The Town of Hilton Head Island Regular Design Review Board Meeting

Tuesday, November 8, 2011

DESIGN TEAM/DRB COMMENT SHEET

PROJECT NAME: Verizon Equipment Cabinet-Union Cemetery Road
DATE: November 8, 2011

1 SITE PLAN
SCALE: 1" = 20'

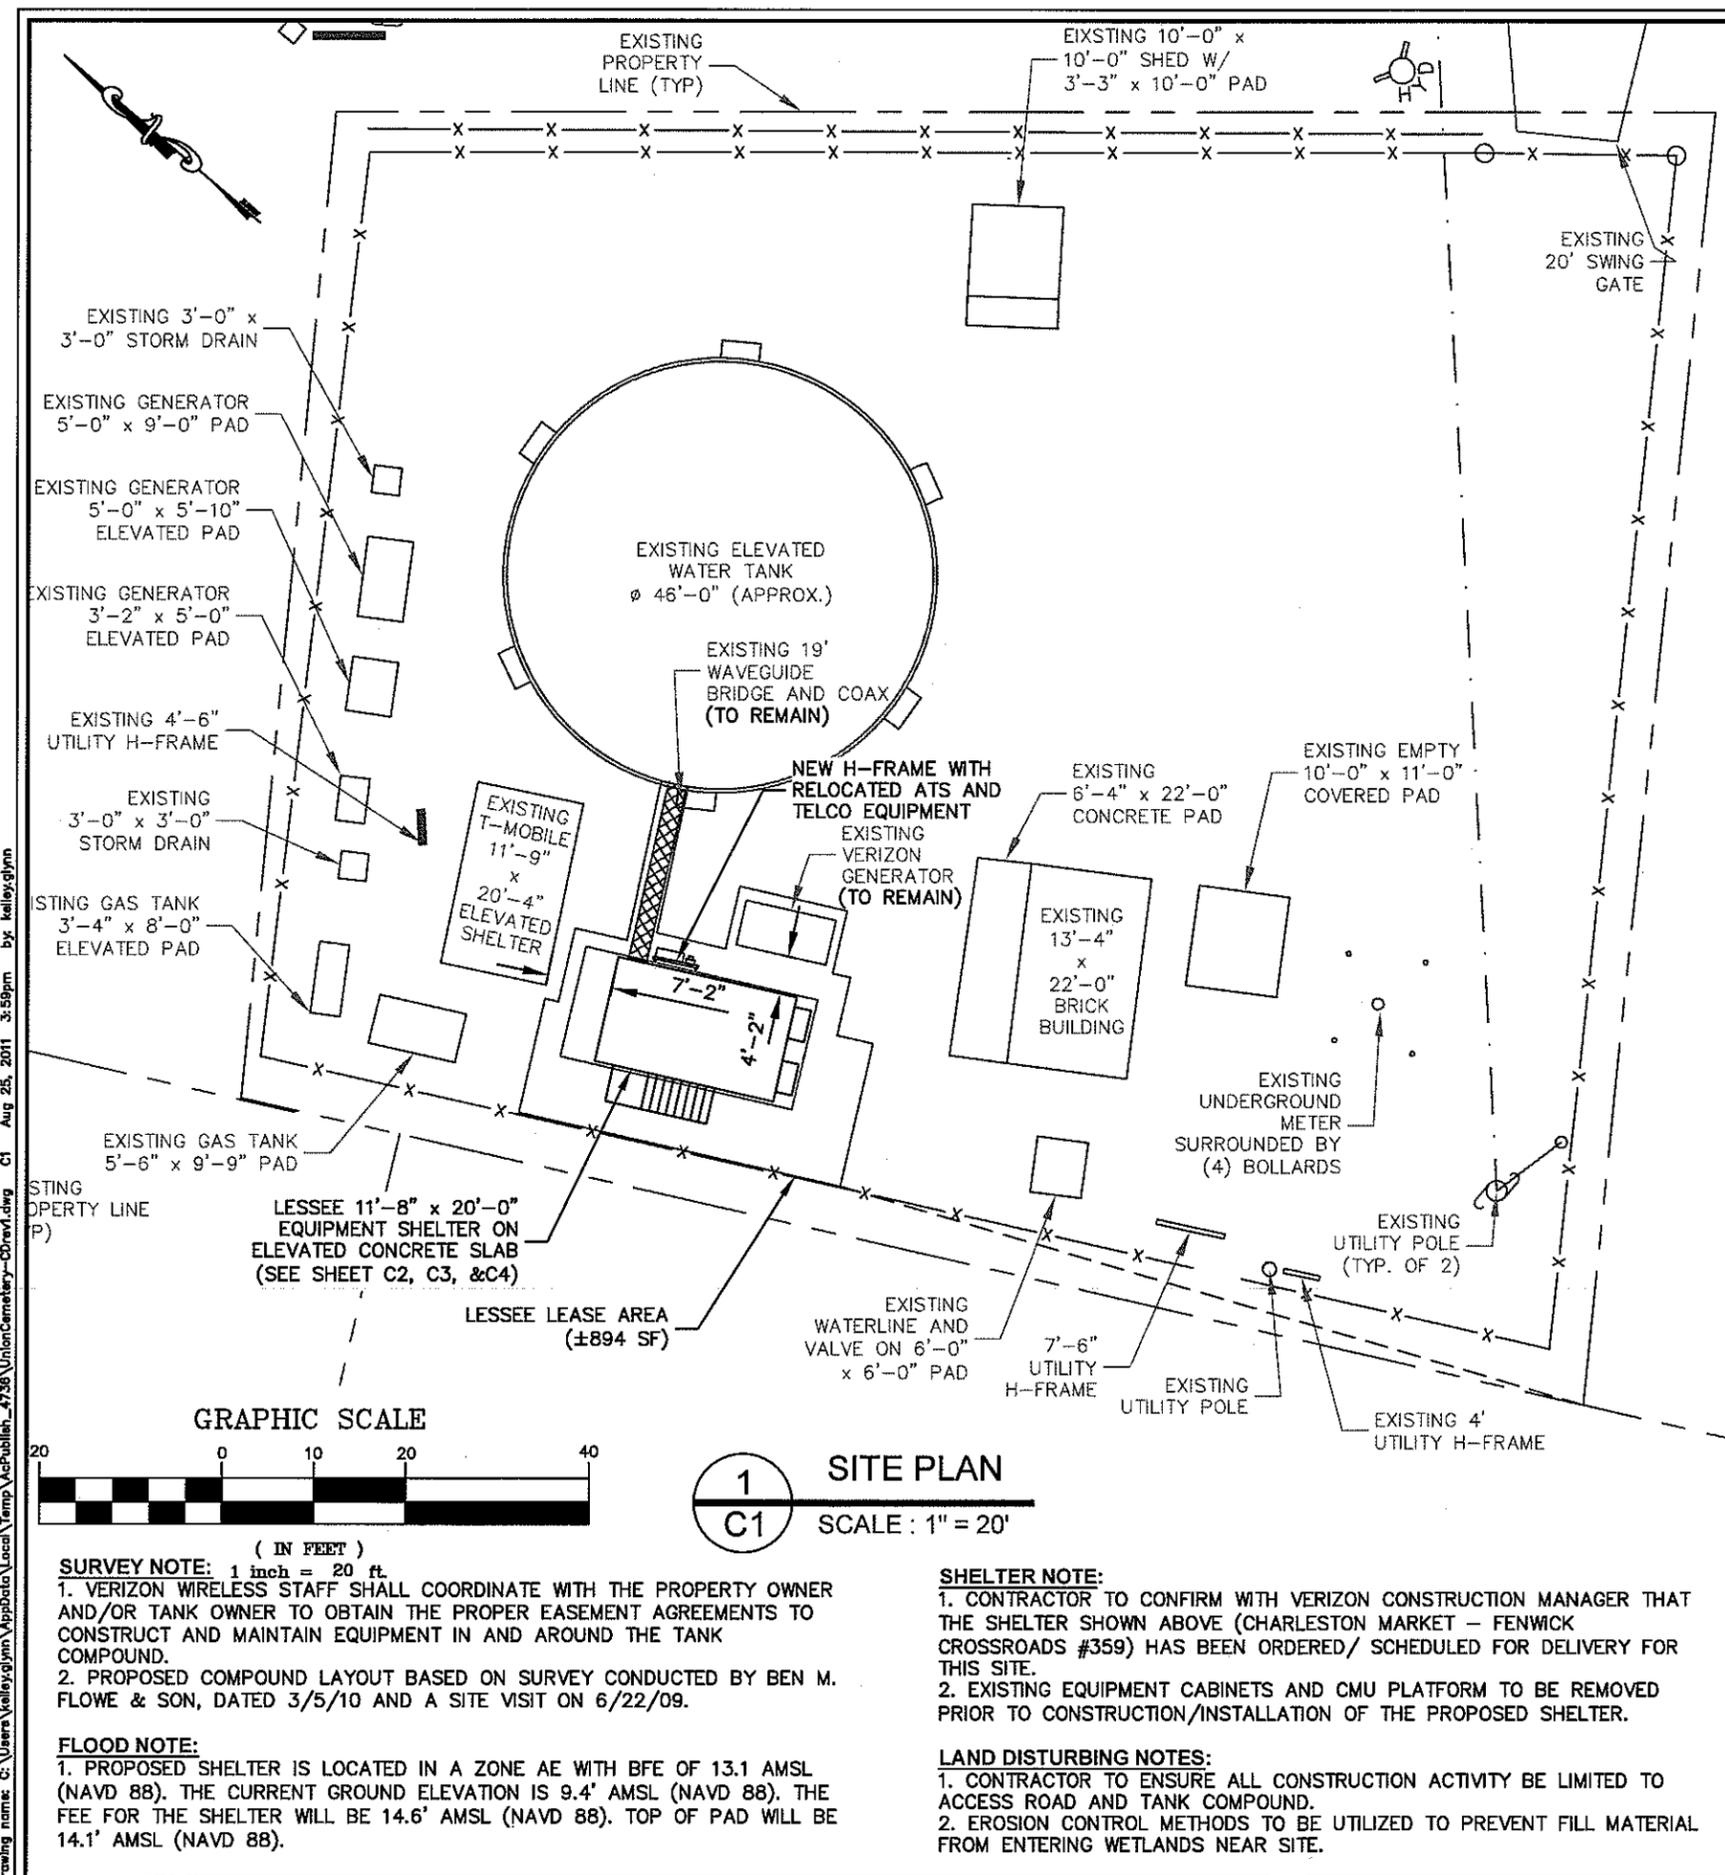
The installation of a new equipment cabinet in an existing yard. Equipment will have to be placed on 4' elevated slab, which will take it above the existing fence line. Adjacent lot is wooded and will not be affected.

1 GRADE
C1.1 1" = 10'-0"

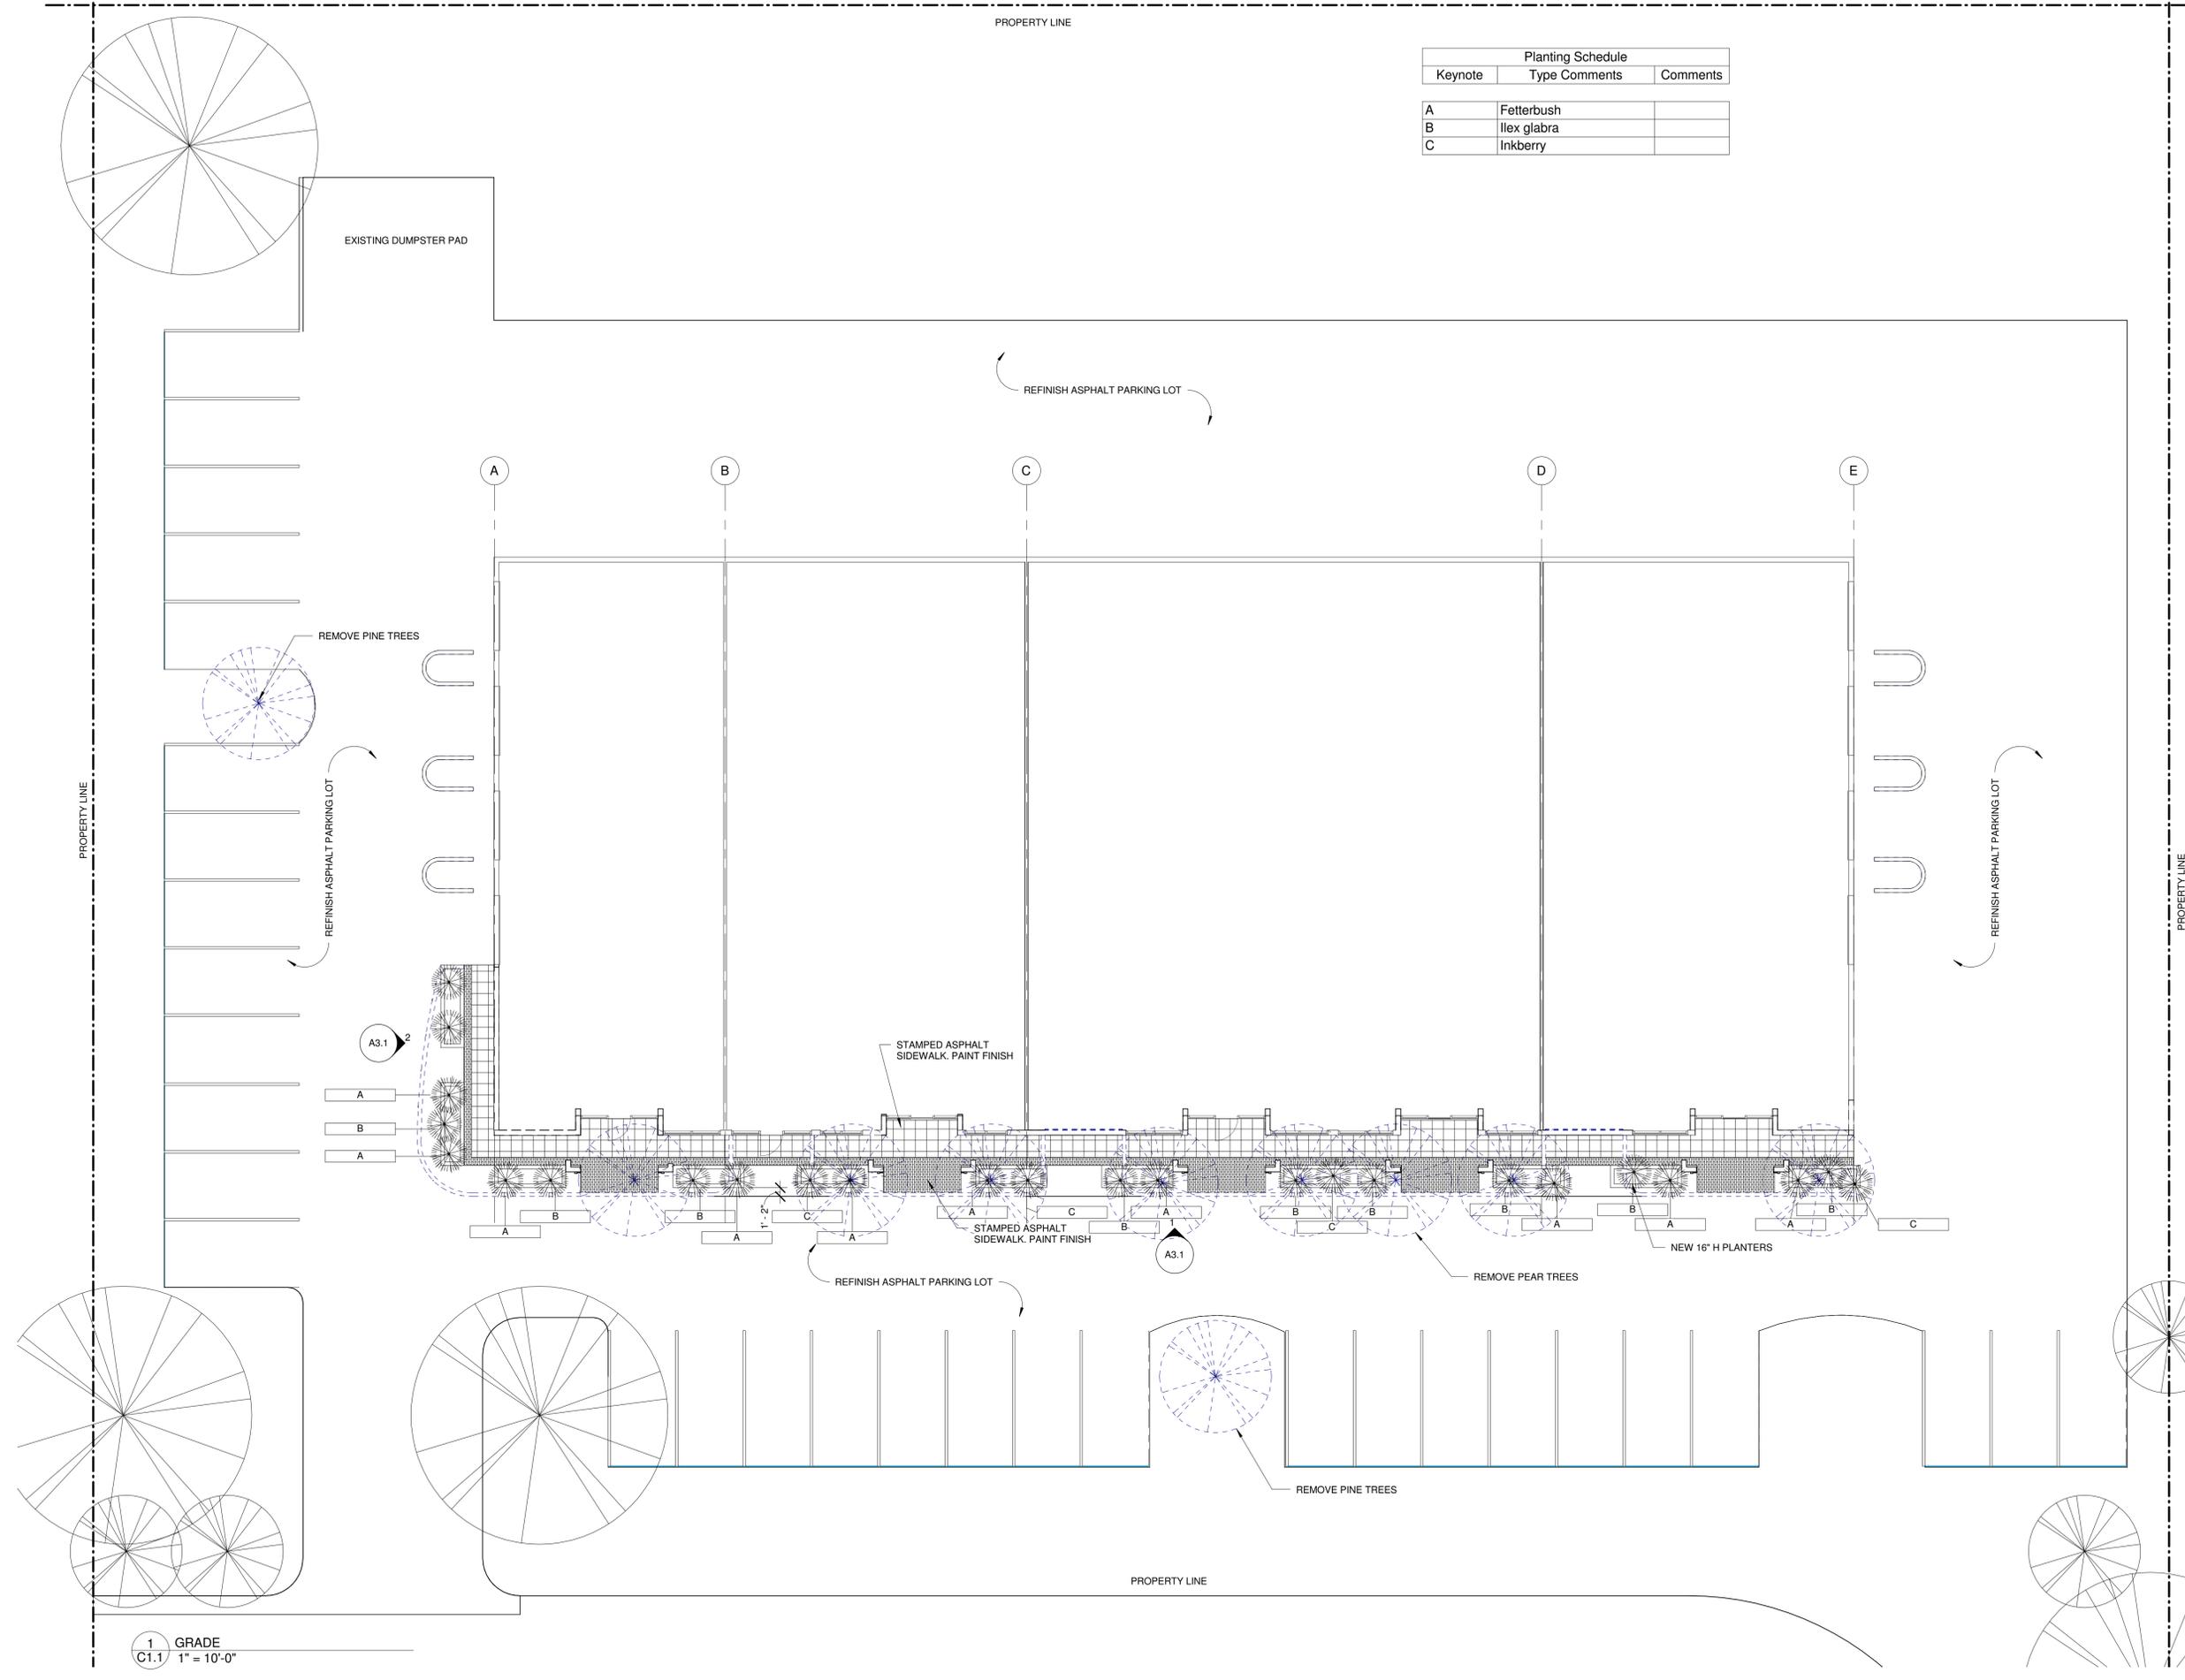
The proposed removal of the pear trees at the front of the building is warranted, and will be treated as a landscape element of the project, although the removal of the pine trees is a matter to be settled with Natural Resources. There are also three palmetto trees on the left elevation that will be coming out, and will need Natural Resource approval as well. Given the absence of landscaping in the parking lot and extent of proposed removal, a full landscape plan should be submitted

SHEET TITLE
EXTERIOR
ELEVATIONS

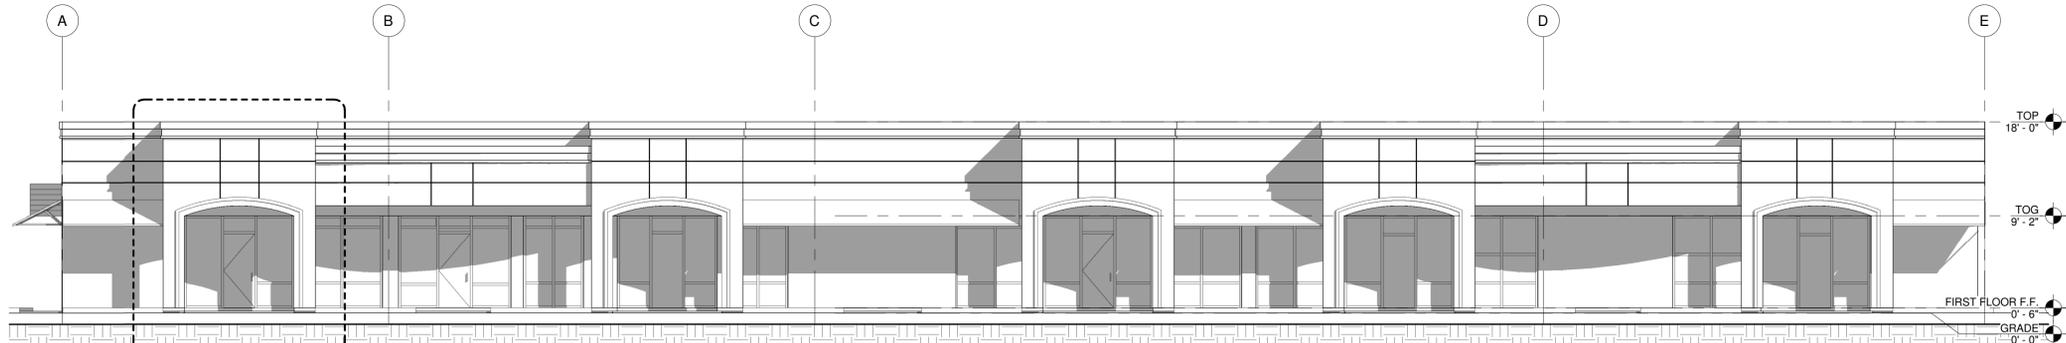
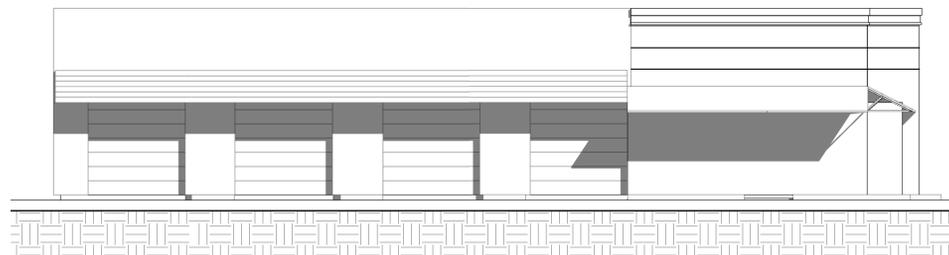
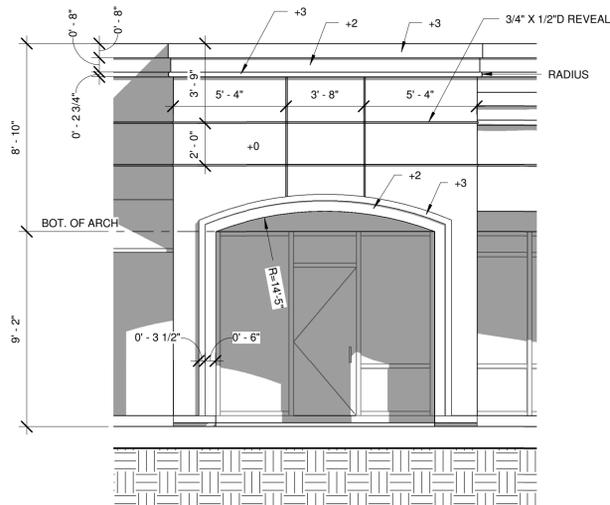
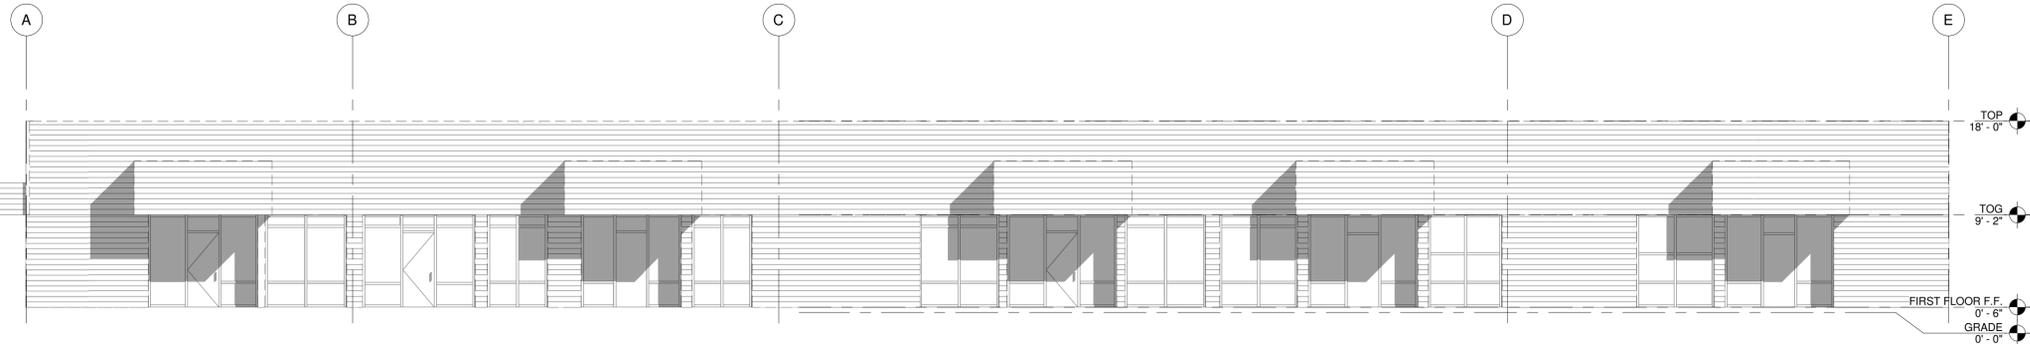
Application is to upgrade the exterior of the 2 Southwood Park Drive Commercial Building. Structure currently has wood siding, storefront systems, and roll up doors on the front elevation. Applicant wishes to remove several trees, improve the respective features, and install awnings/ canopies along the front of the building. Wood siding will be replaced with a stucco finish.

Application proposes the installation of stucco planters along the front of the building, although no detail is provided.

The Design Guide recommends avoiding flat roof forms. While the improved entry features are a significant step in the right direction, perhaps some pitched element might keep them closer to what the Guide is trying to ensure. While staff does not advise that the applicant pull directly from it, the Triangle Square renovation utilized a similar improvement, which was well received and is more in keeping with the Guidelines of the Town (see below). Perhaps it might provide some insight.
